# NORTHEAST UTILITIES

June 20, 1984

Millstone Nuclear Power Station, Unit No. 3  
Millstone 3 Site Visit by Auxiliary Systems Branch Reviewer, June 13, 1984

#### ASB-22 PRESSURE AND TEMPERATURE PROFILES FOR PIPE BREAKS OUTSIDE CONTAINMENT

Figure 1  
Main Steam Valve Building  
Nodal Diagram

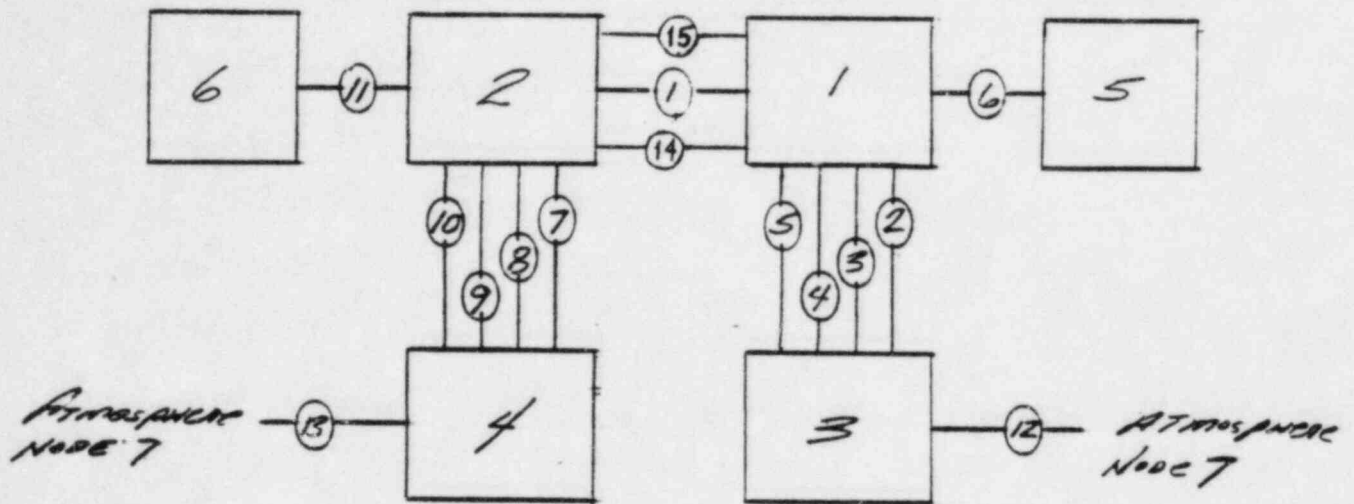
Provide the following information to perform an independent calculation for verifying environmental conditions in a compartment (e.g. Main Steam Valve Building) after a high energy line break.

- v. number of vents and vent areas (square feet) for each vent; and
    - vi. compartment wall height (feet) and
  - c. Simple compartment and interconnection diagram.

The MSVB is modelled by six interconnected nodes as shown in Figure 1. A sketch showing the location of the nodes is given in Figure 2. Input data for the thermal-hydraulic calculations are described below.

FIGURE 3  
MILLSTONE 3 MSVH 1.0 SQFT MSLB IN NODE 1  
PRESSURE VS. TIME  
PROFILE NODES 1 THRU 6

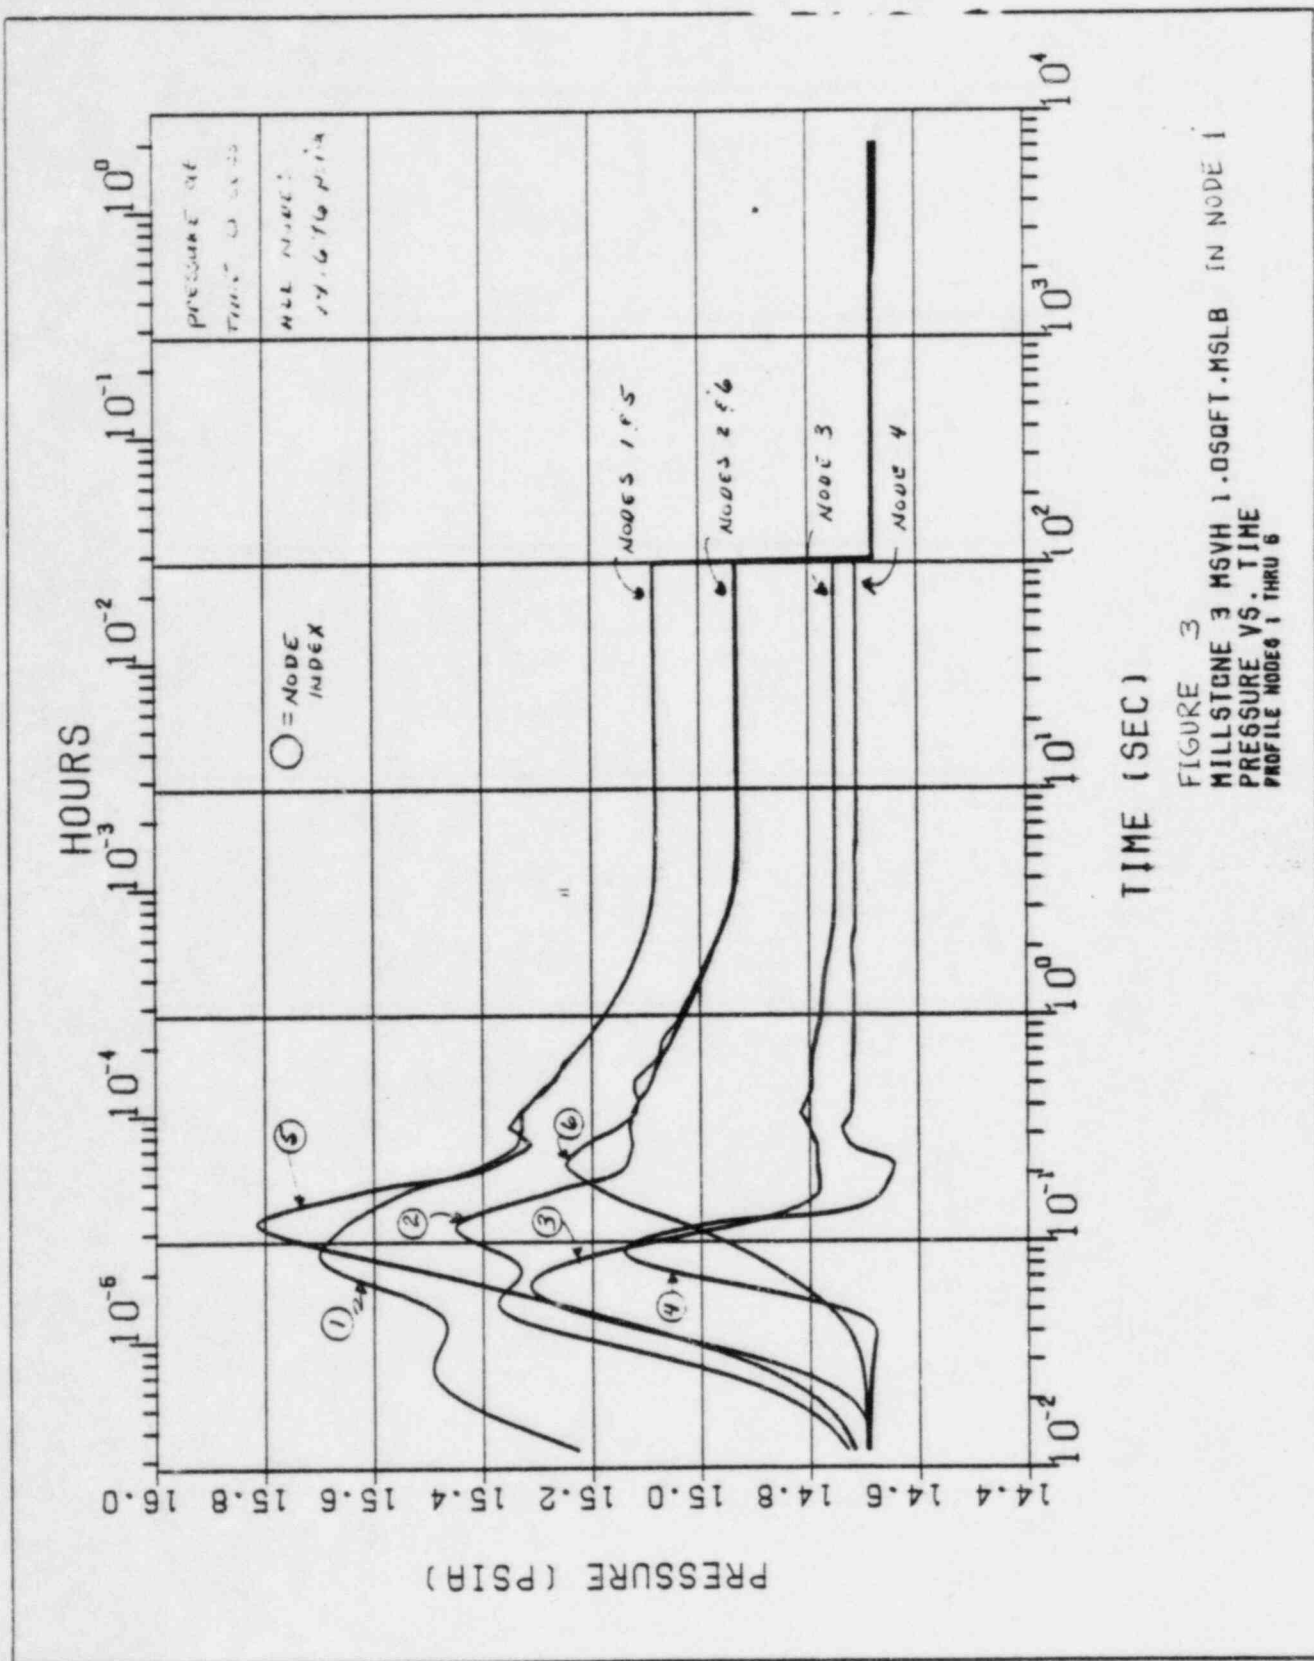
4. Utilities analysis results:
  - a. Temperature versus time curve (peak temperature specified);
  - b. Pressure versus time curve (peak pressure specified); and

The peak calculated pressure and temperature in the MSVB was 15.82 psia and 292.4°F, respectively. Complete pressure and temperature transients for each node of the building are given in Figures 3, 4 and 5. The relative humidity is 100% for the duration of the transient.
